DECISION REPORT

PLAN CHANGE 94 – Washer Road Business Park

FILE REFERENCE: A4524970

Figure 2: Proposed changes to Planning Map U125 to include land within the Industrial Zone (shown purple).

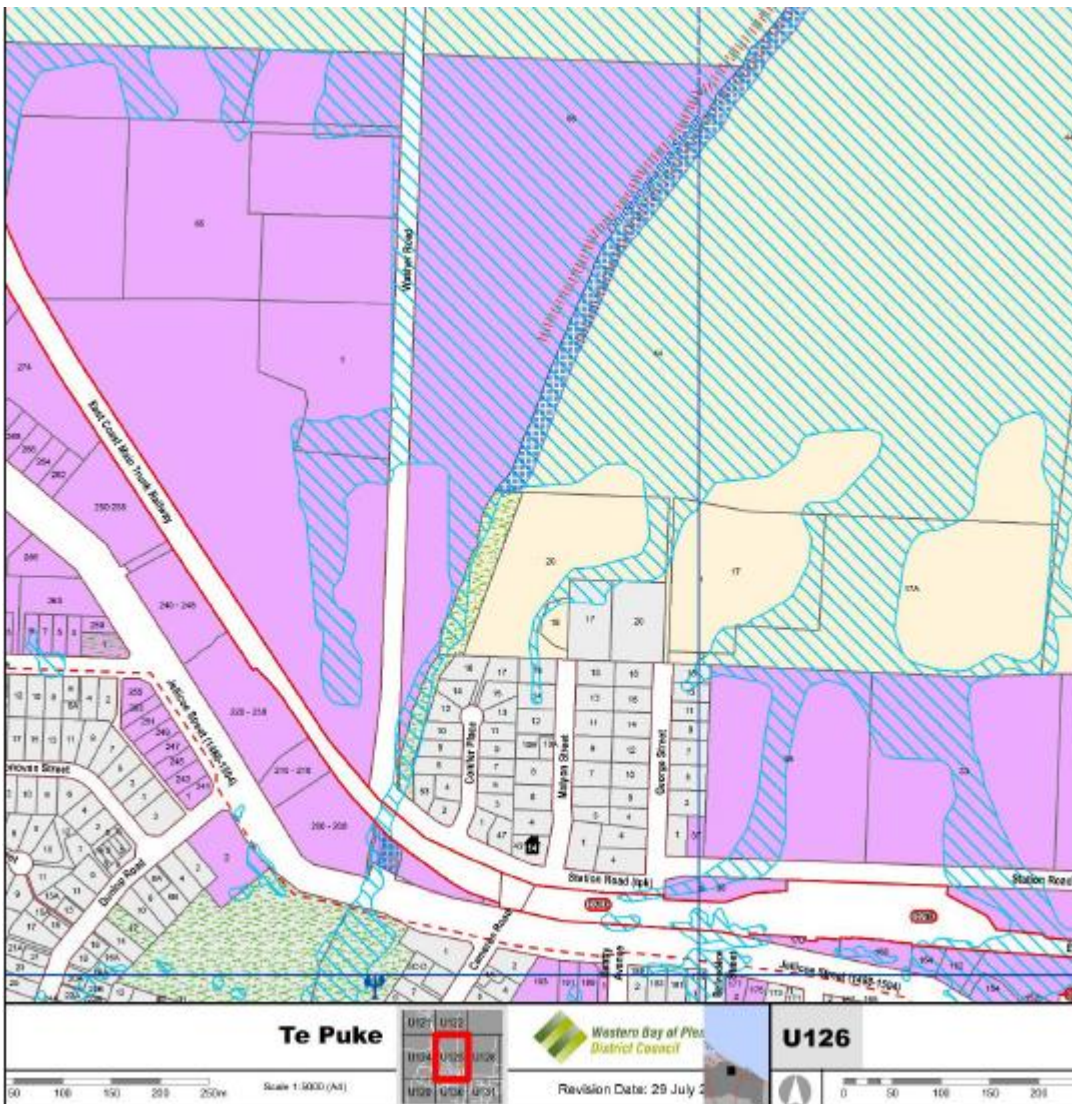
Submission 1.2 – Supports the proposed rezoning of the site to Industrial Zone as it will provide much needed industrial land in Te Puke.

Option 1 is adopted – That the land be re-zoned from Rural to Industrial as notified.

Rezoning the land from rural to industrial will help meet the immediate demand for industrial sites and complements the adjoining Industrial Zone. It will also provide growth opportunities to meet the employment and business needs of the community.

WASHER ROAD BUSINESS PARK Plan Change Structure Plan

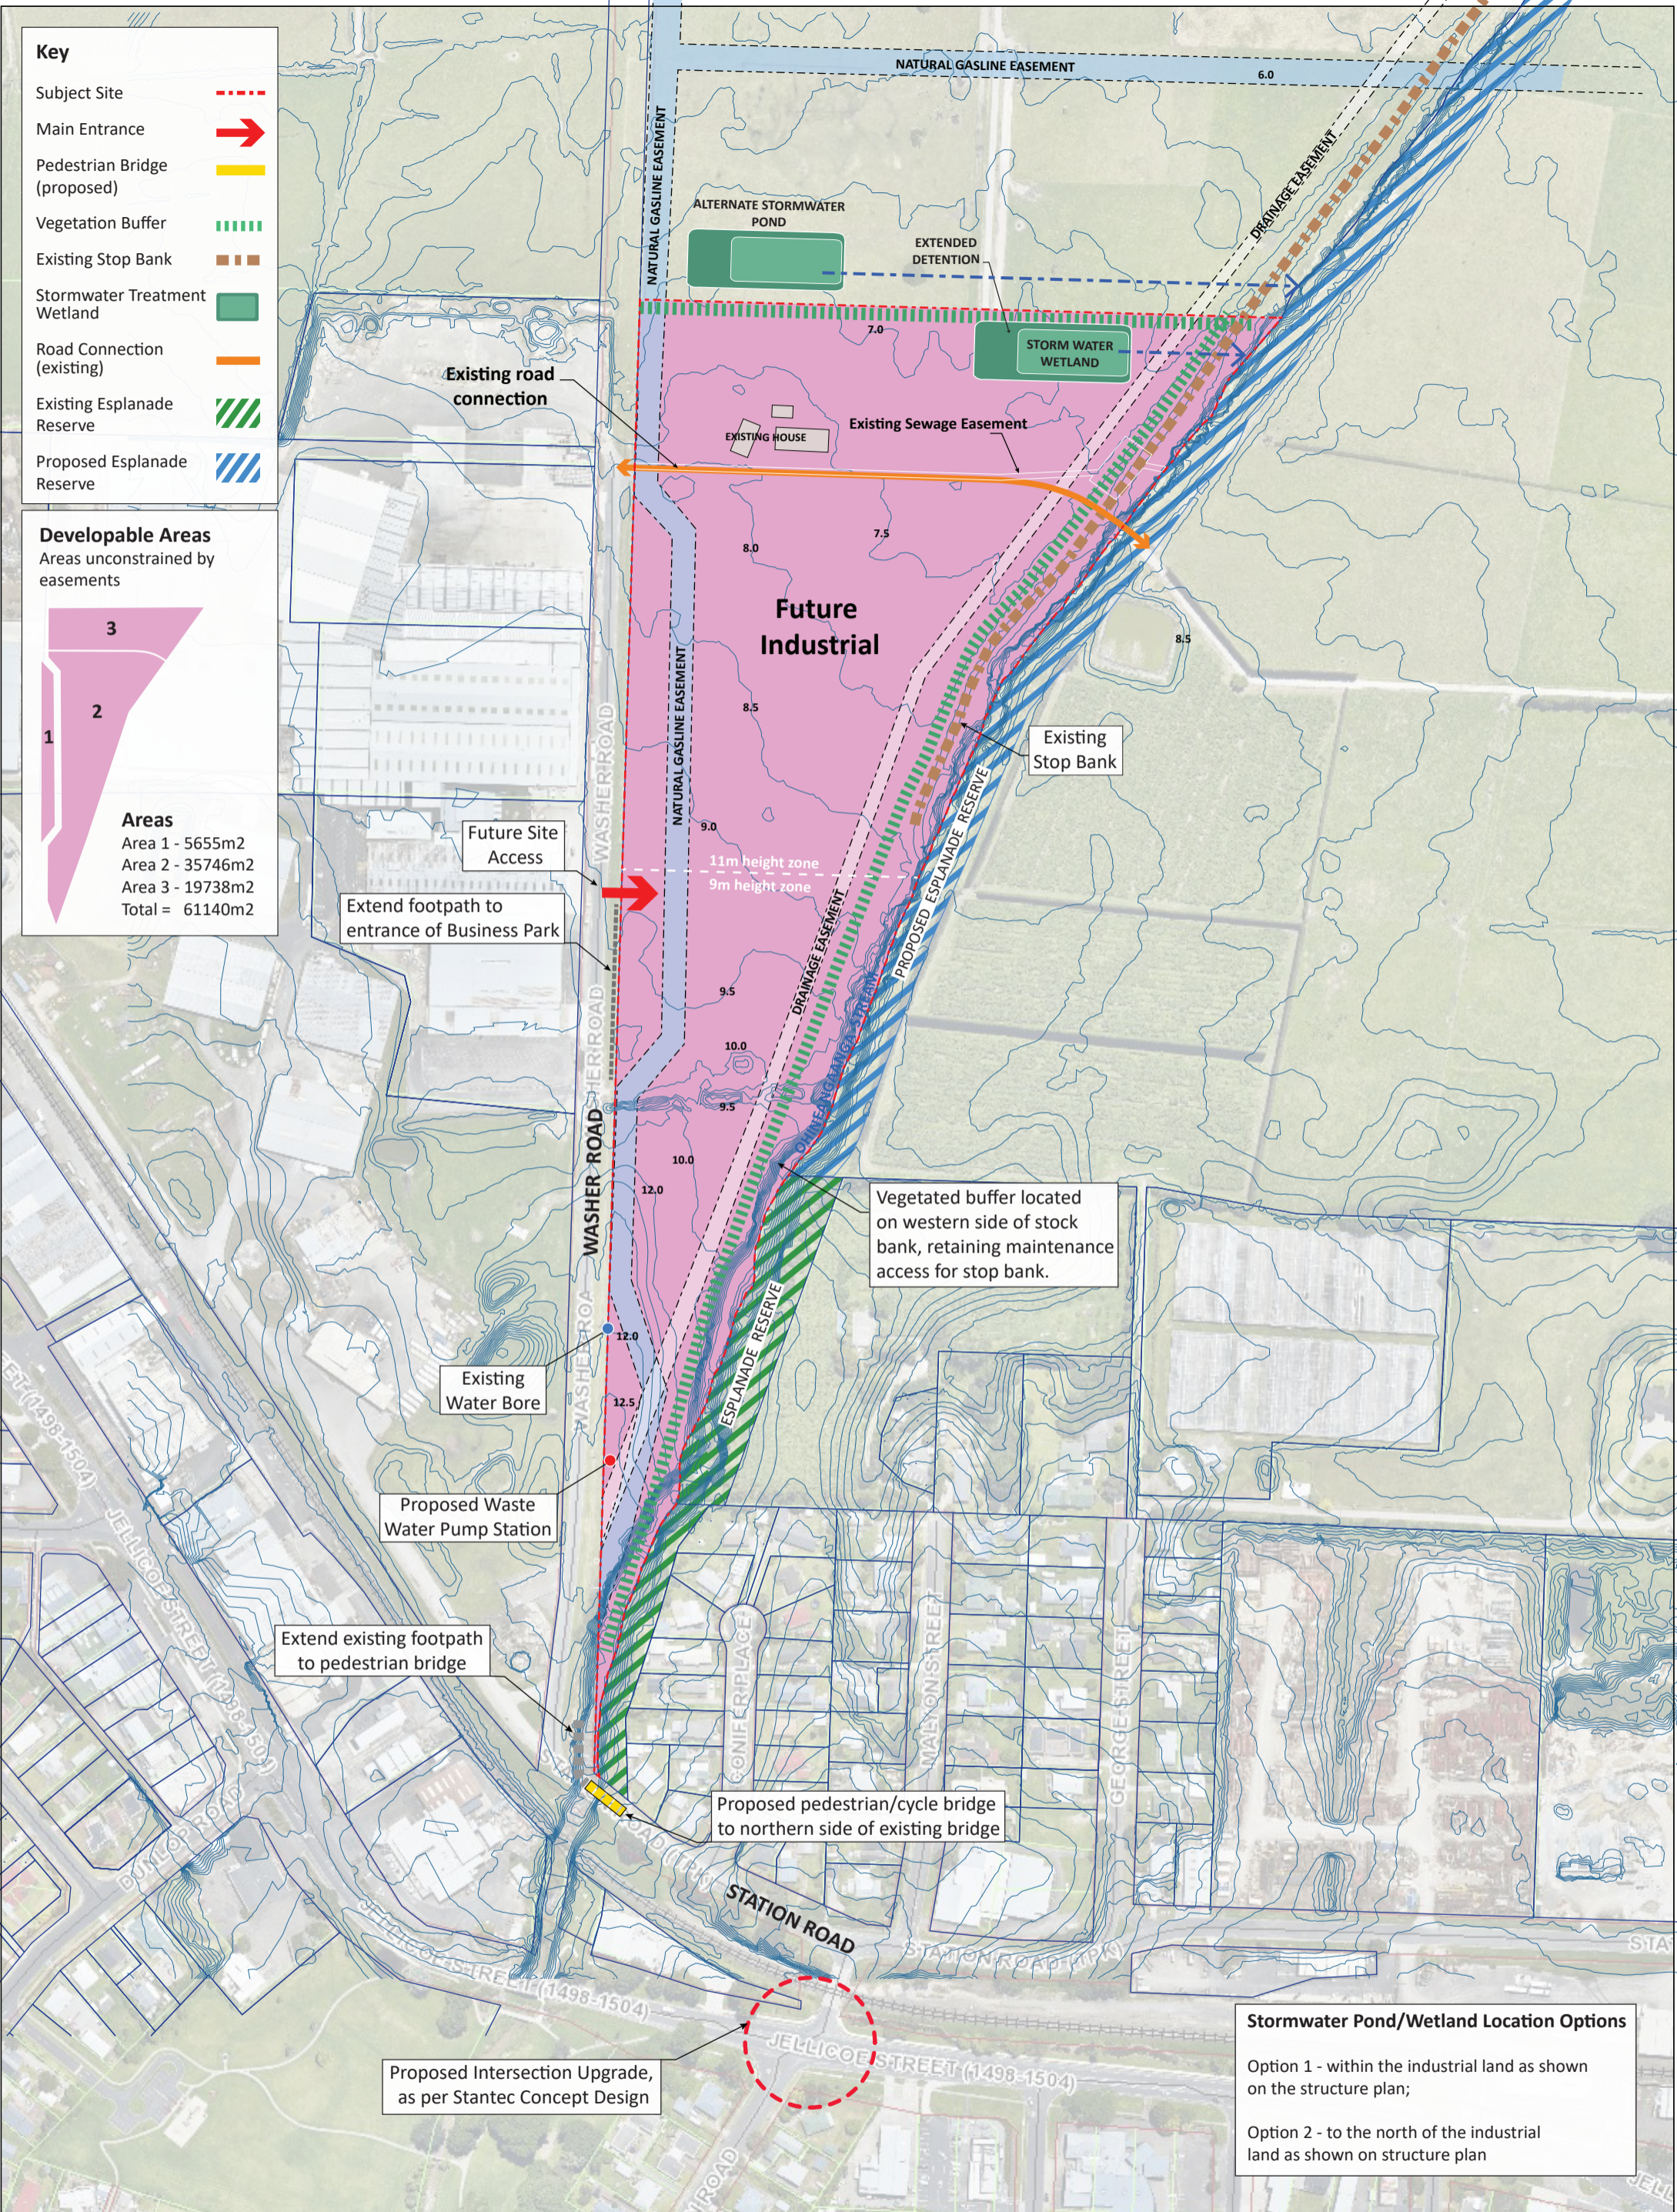
The concept of the landscape buffer is supported by the submitters; however access is required to both sides of the Ohineangaanga Stream in order to maintain the canal banks and the adjacent stopbanks. Consequently, any landscape buffer should be from the landward toe of the stopbank only to ensure:

BOPRC noted that the stopbanks in this vicinity are likely to be raised in the near future. This will mean that the existing toe of the left bank stopbank will be pushed further to the west.

Submission 4.1 – Requests that the gas transmission pipeline and 20m buffer be shown on the Structure Plan map, and that the landscape strip is removed from over the gas transmission pipeline.

During the Hearing the Applicant's experts tabled an updated Structure Plan in response to some of the submitter's evidence. The tabled Structure Plan moved the stormwater pond just north of the area proposed to be rezoned Industrial, but retained on the applicant's land to provide additional land for stormwater treatment. The Regional Council questioned whether the pond could be relocated

Option 2 is adopted. That the following Structure Plan, Staging Plan and associated Schedule of Works - Staging Details which were presented at the Hearing by the Applicant and modified by other decisions below be adopted.

The updated Structure Plan also shows the location of the landscape strip to the west of the toe of the stopbank, and the Panel support the updated location.

First Gas requested the easement be shown on the Structure Plan, and it is noted that it currently is. Further Firstgas provisions are considered in Topic 8 below.

For clarity the Applicant has provided an updated Structure Plan Map which is included In the Topic 2 Decision above. This shows the two options for the location of the stormwater pond to provide flexibility in the future.
